Request for Additional Information No. 150 (1656, 1606), Revision 0

U. S. EPR Standard Design Certification

AREVA NP Inc.

Docket No. 52-020

Figure 12.02-2-1—Diagram for Primary Confinement Service Area Airborne Activity During Normal Operation

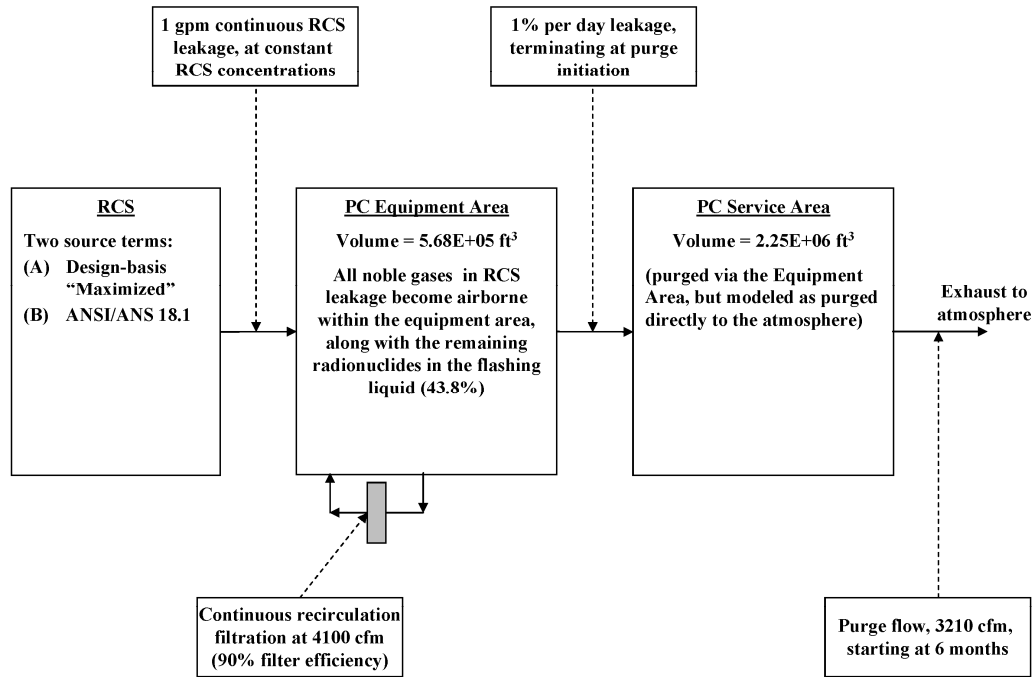
- a) It is not clear from the parameters listed in Table 12.2-19, Parameters and Assumptions for Calculating Airborne Radioactive Concentrations, how the airborne concentrations were calculated for the EPR. Please provide sample airborne radioactivity concentration calculations for the fuel and reactor buildings such that NRC staff can independently verify the methodology used and the concentrations reported in the FSAR. Include all equations, assumptions and any default values that may have been used.

The airborne concentrations were calculated for U.S. EPR fuel and reactor buildings using the ELISA-2 computer code considering leakage from the reactor coolant system (RCS) using guidance in RG 1.206, Section C.I.12.2.2. The production of Ar-41 was separately determined.

Values for the parameters shown in U.S. EPR FSAR Tier 2, Table 12.2-19 were input into ELISA-2 computer code to model the releases in the Reactor Building as shown in Figure 12.02-2-1.

Figure 12.03-12.04-4-1—Example of AMS Measurement Table Currently in Use for KONVOI-Type Plants

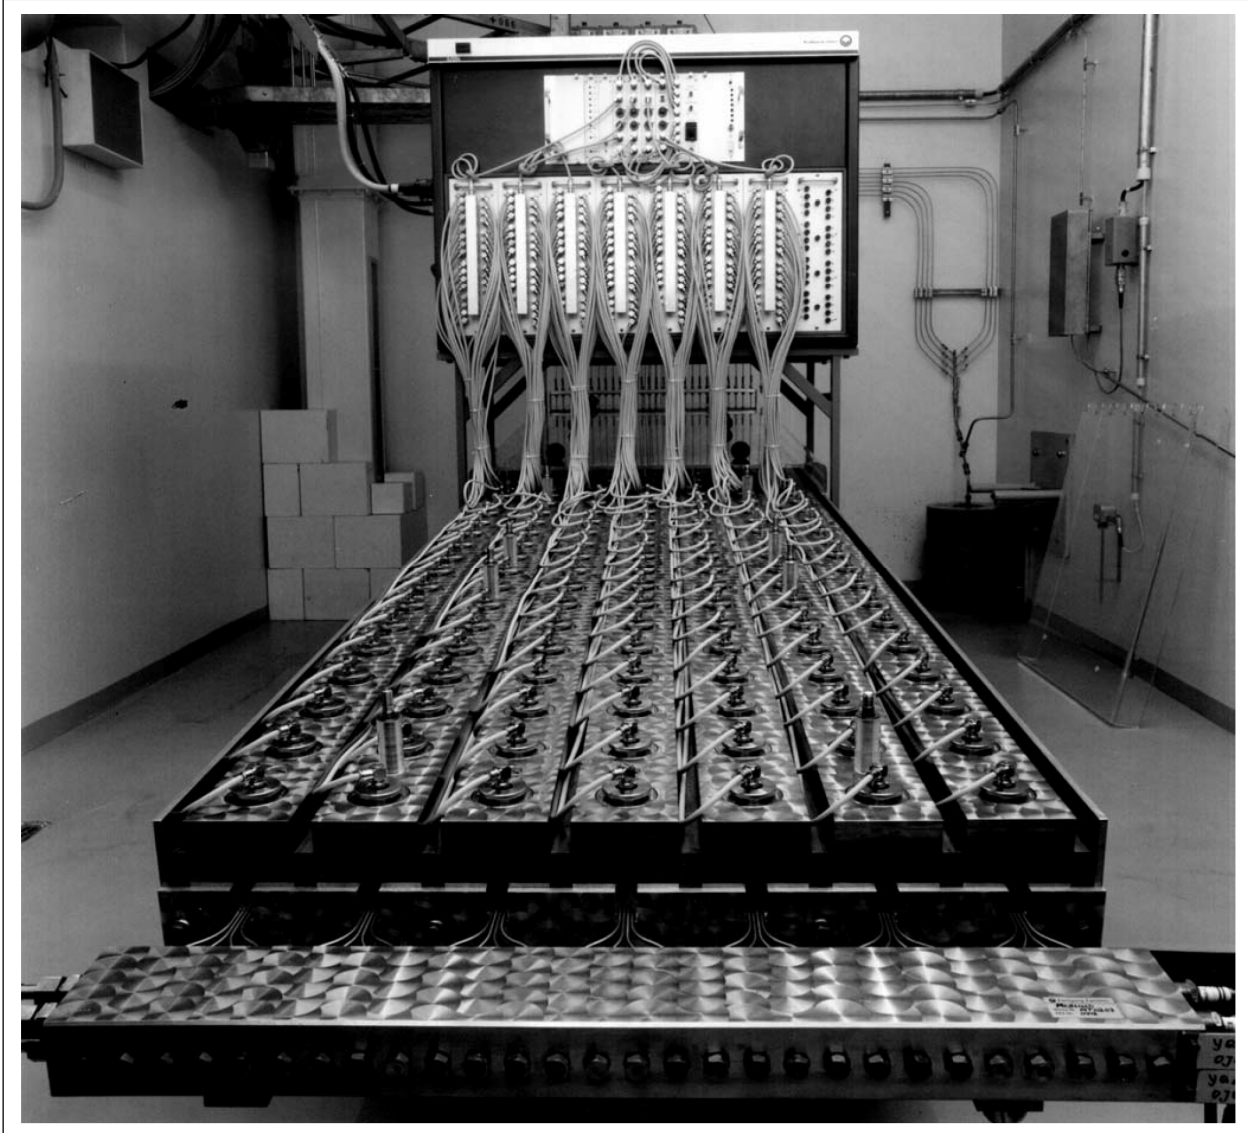
- ii) Provide information or a drawing describing where and how the activation probes are stored following transit from the core (and assuming they are not located in the measurement room). Provide information or a drawing describing the shielding at the storage location to ensure that dose rates to personnel in the area are maintained ALARA.

The measured activity distribution along the Aeroball measurement table stacks (see Figure 12.03-12.04-4-1) is proportional to the neutron flux density and thus, to the power density in the measured region of the reactor core. The result is a three dimensional power density distribution for the reactor core which can be used to calibrate the self-powered neutron detectors. The balls are designed to be used for the life of the plant without the need for replacement since there is negligible depletion of V-51 during each measurement. Nevertheless, the balls can be replaced if Aeroball transport problems occur.

Figure 12.03-12.04-4-5—Total Activity for Aeroballs as Function of Decay Time for Various Times Between Usage
(inset provides full range)

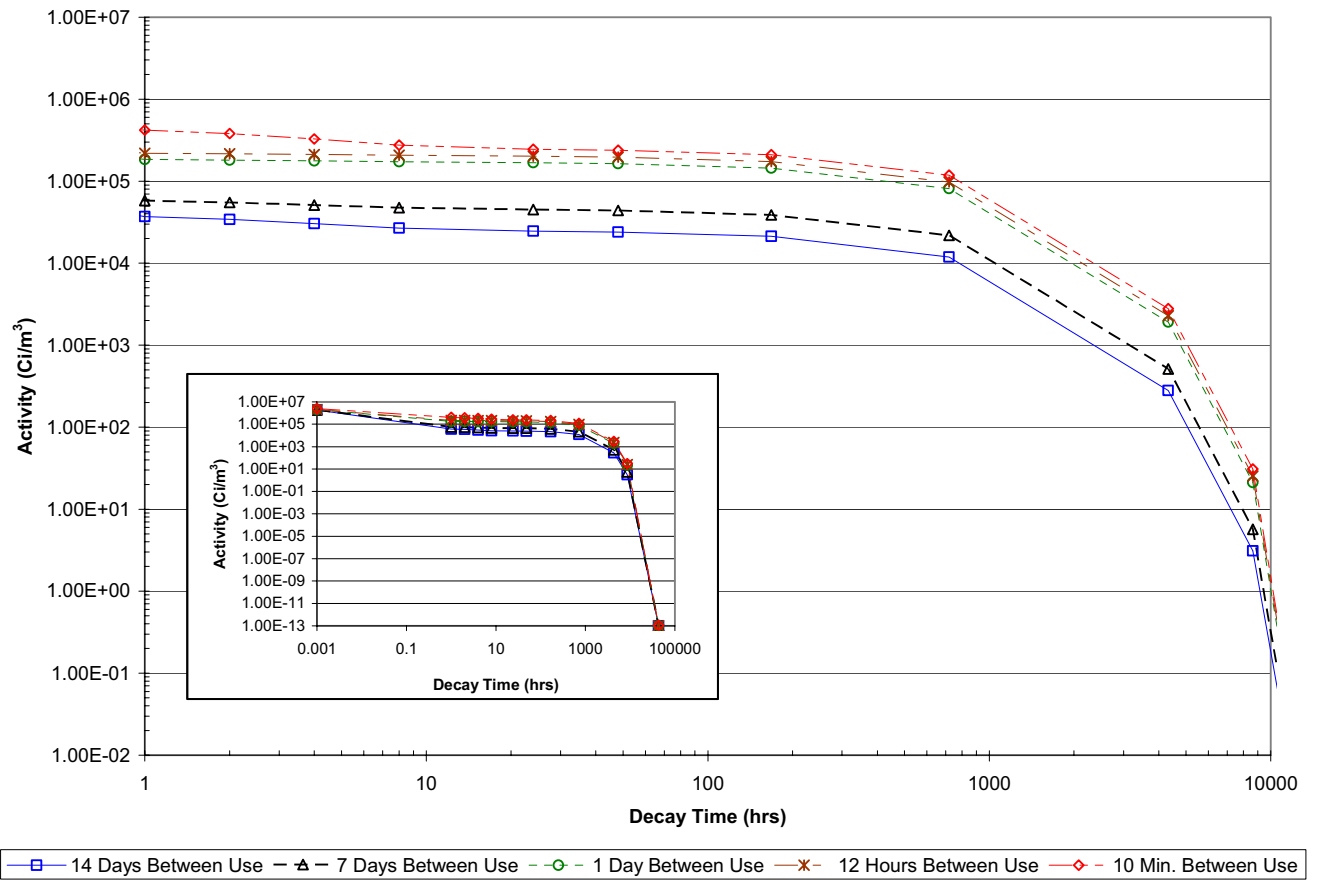
- iii) Provide the isotopic composition and source strengths for the aeroballs following the maximum expected use time at 100% power (including stuck detectors). Also provide source strengths projected over a 3 week period (such as a refueling outage).

The content of the alloy elements with their tolerances are specified in detail and verified after fabrication by chemical analysis. During commissioning, two ball stacks will be activated so that they reach saturation. Their activity will then be measured to establish time dependence and decay constants of the material components.

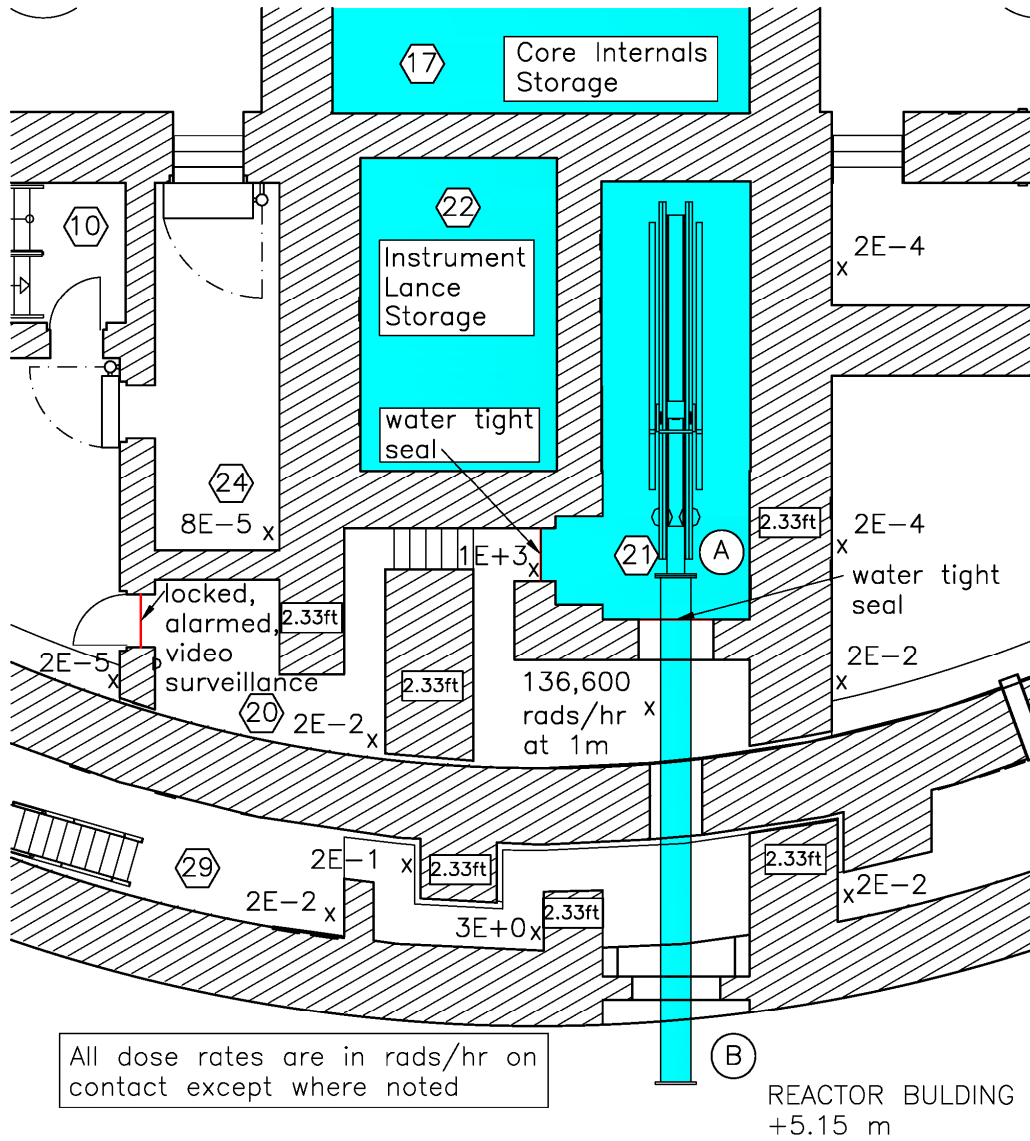
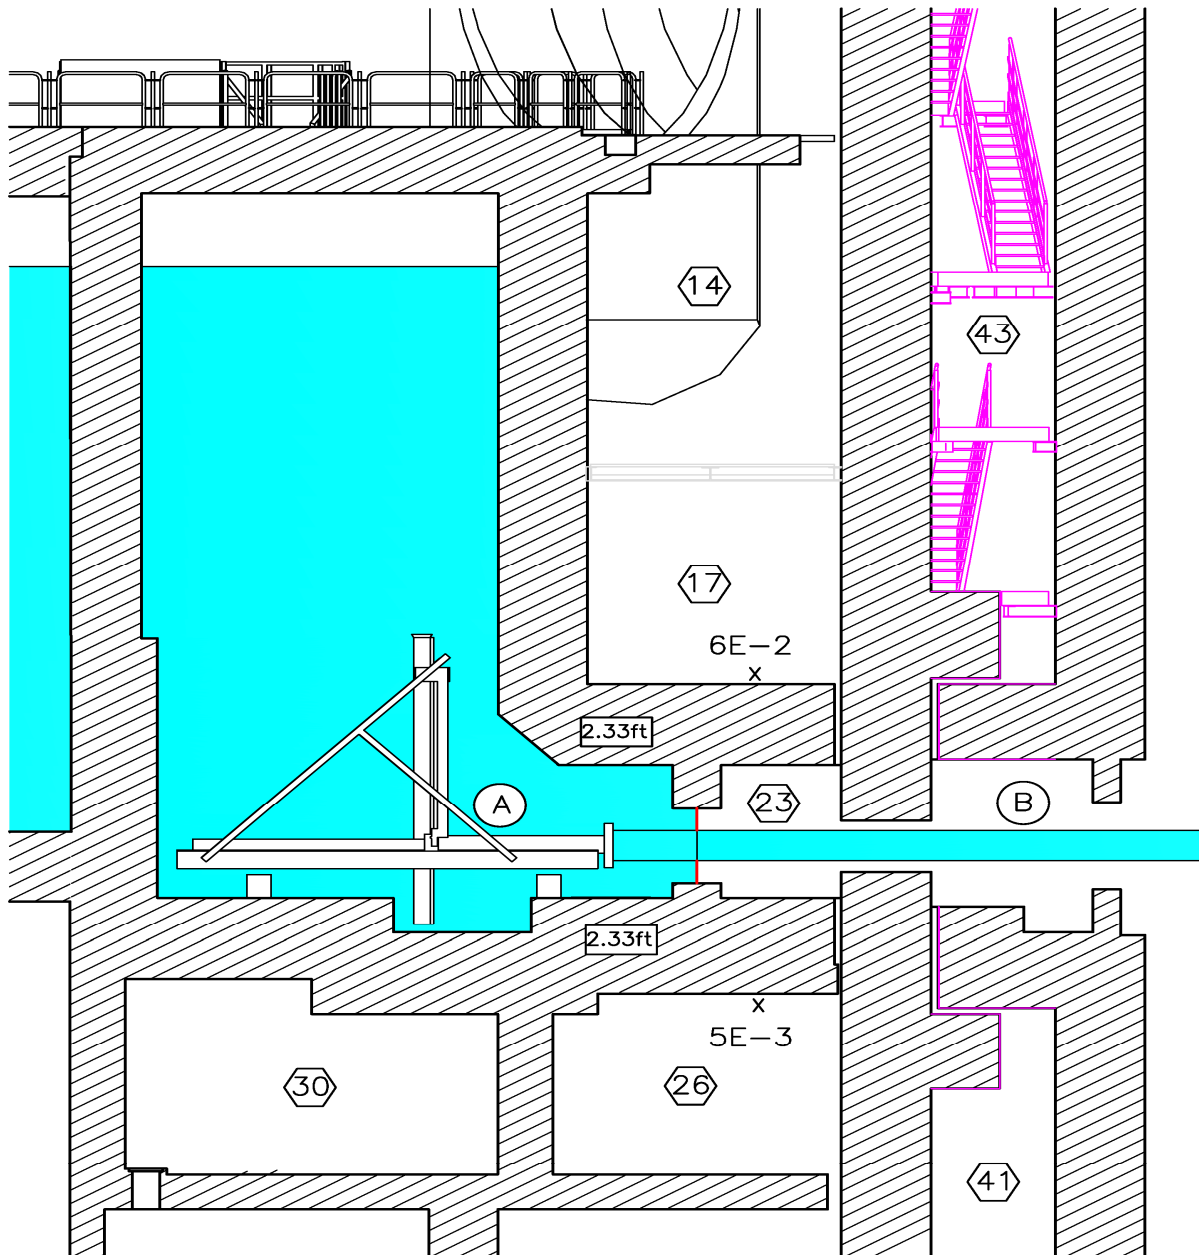
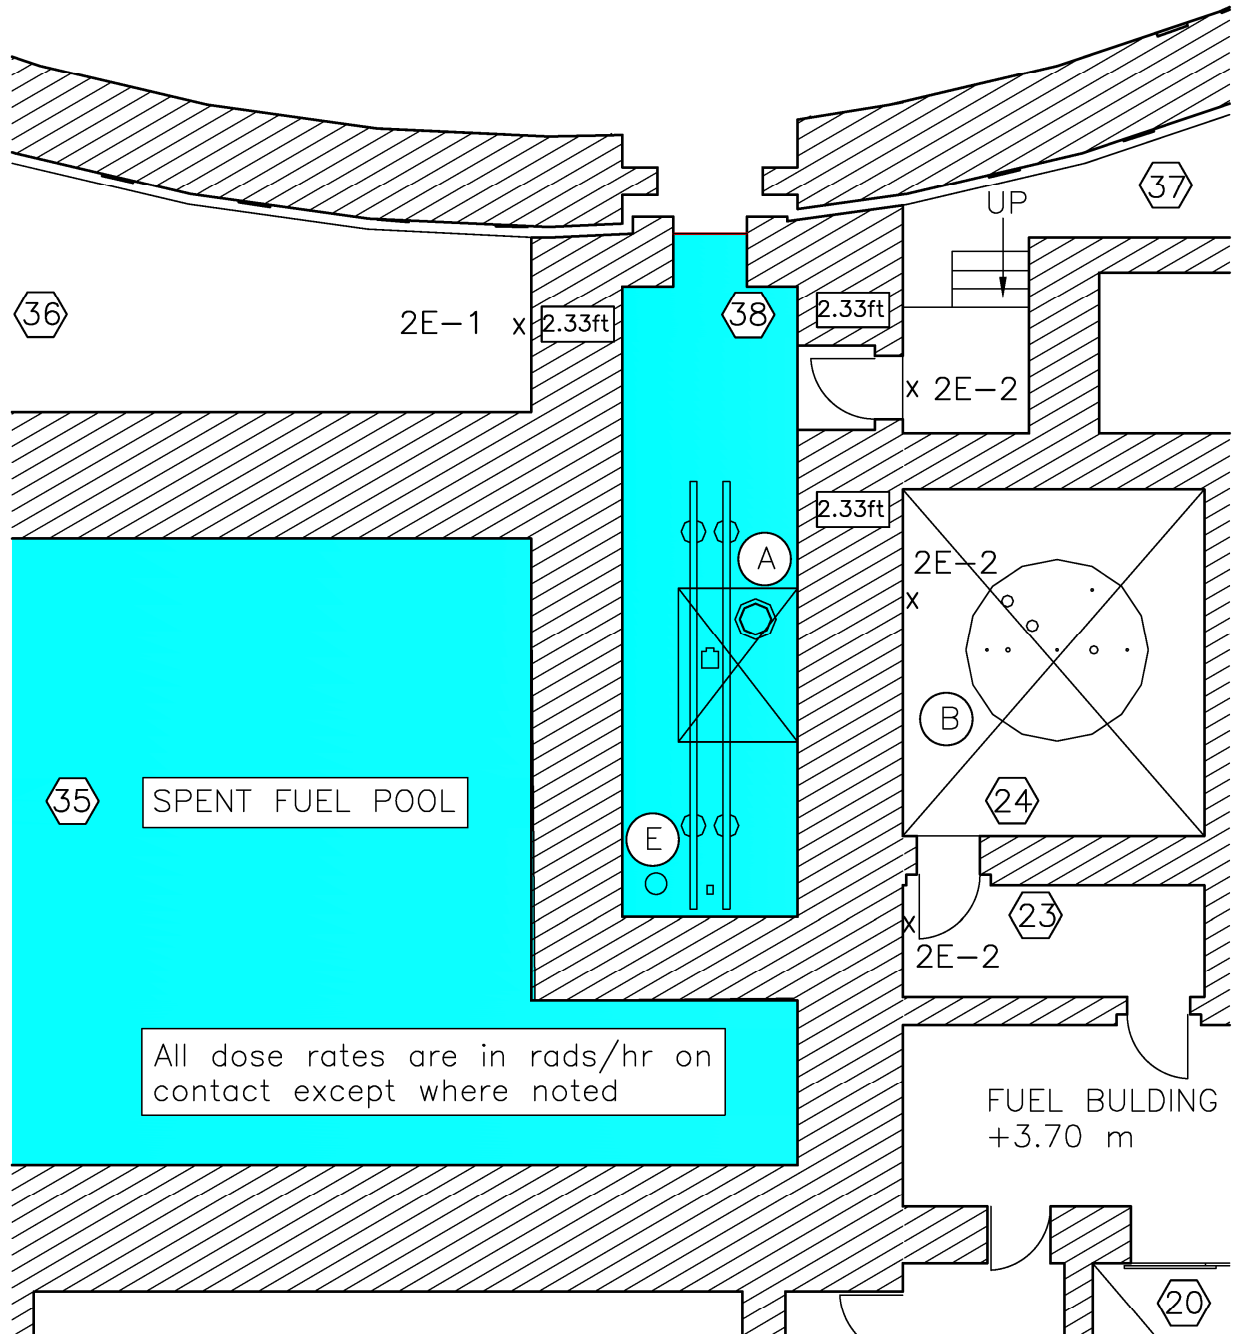
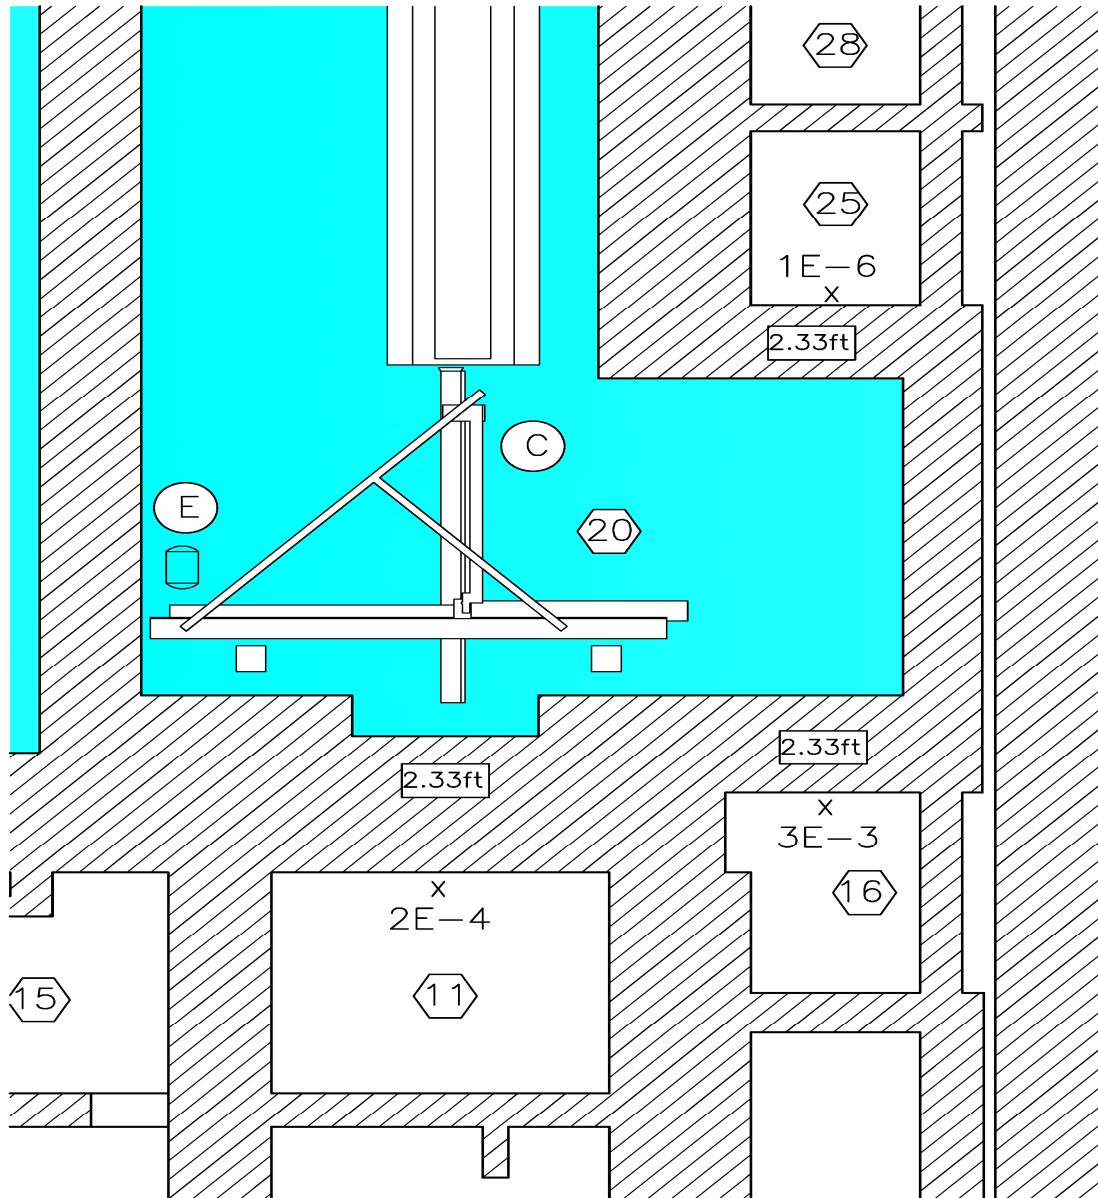
Figures 12.3-9, “Containment Building Section Looking Plant-East as the Reactor Cavity, Core Internals Storage, Transfer pit, and Spreading Area,” and Figure 12.3-4, “Transfer pit at the +17 Ft Elevation in the Reactor Building,” provide a view of the spent fuel transfer pit as well as areas adjacent to the pit within the reactor building that could be occupied. Provide information on the minimum concrete thickness between the pit and these potentially occupied areas within the reactor building, as well as the estimated dose rates in these areas during spent fuel transfer. Discuss design features that will be in place to control access to high radiation areas adjacent to the fuel transfer pit during fuel transfer (for example, the “access to transfer pit” rooms shown in Figures 12.3-34, “Fuel Building +12 Ft Elevation Radiation Zones,” and 12.3-4).

The minimum wall thickness required to maintain dose rates in occupied areas adjacent to the fuel transfer tube less than 100 rads per hour is 2.33 ft. Figures 12.03-12.04-6-1 through 12.03-12.04-6-4 show this value in a box on the credited walls and floors. The estimated dose rates in the spent fuel transfer tube compartment and occupied adjacent compartments are shown in these figures, represented by an ‘X’ where the contact dose rate is estimated along with a value representing the estimated dose rate in rads per hour. These dose rates are also presented in Table 12.3-12.04-6-1.

- Figure 12.03-12.04-6-1 is taken from Figure 3B-6.
- Figure 12.03-12.04-6-2 is taken from Figure 3B-14.
- Figure 12.03-12.04-6-3 is taken from Figure 3B-19.
- Figure 12.03-12.04-6-4 is taken from Figure 3B-28.
